FST2XT Software Change History

Issued by: NEW Lift Steuerungsbau GmbH

Release: FST V0156, 31.01.2020

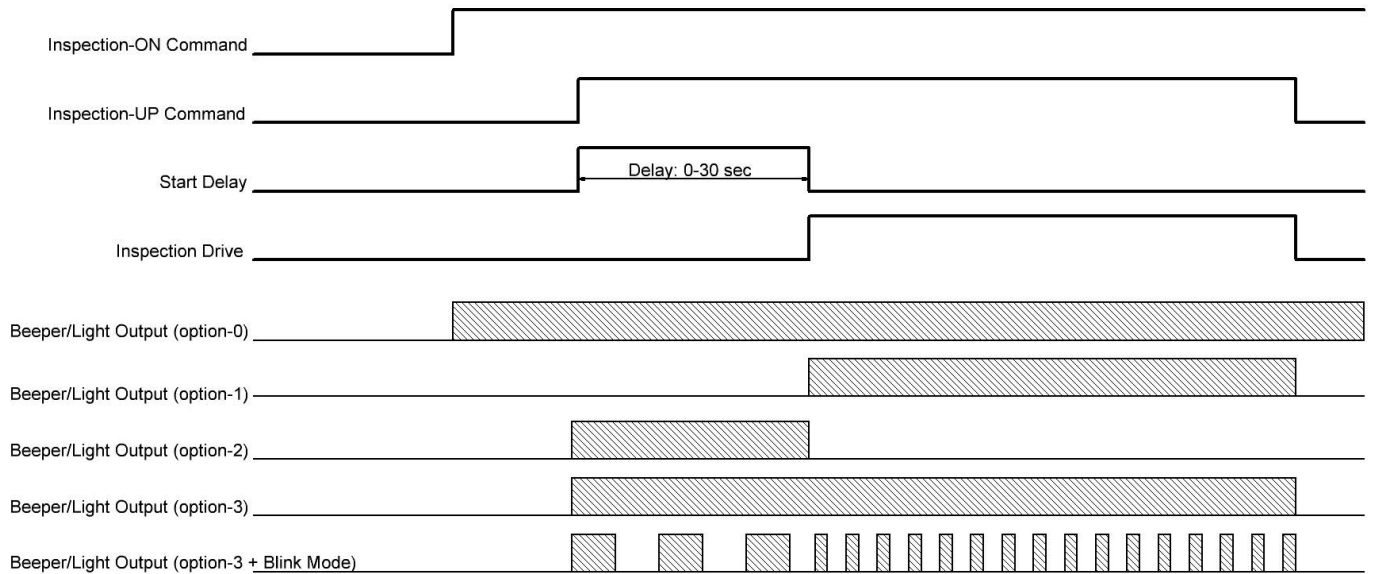
2) Inspection end-switch Monitoring: New function added for Shaft-Top or Bottom switches. The function is set to operate by using one or two of the new input I/O Port:

Menu: Port RAW = 0000 0000 0000 000T 0100 0010 1111 001x

T=0 tests input for activation in Bottom floor

T=1 tests input for activation in Top floor

eg. for Top endswitch: I/O Port = 000142F2
for Bottom endswitch: I/O Port = 000042F2
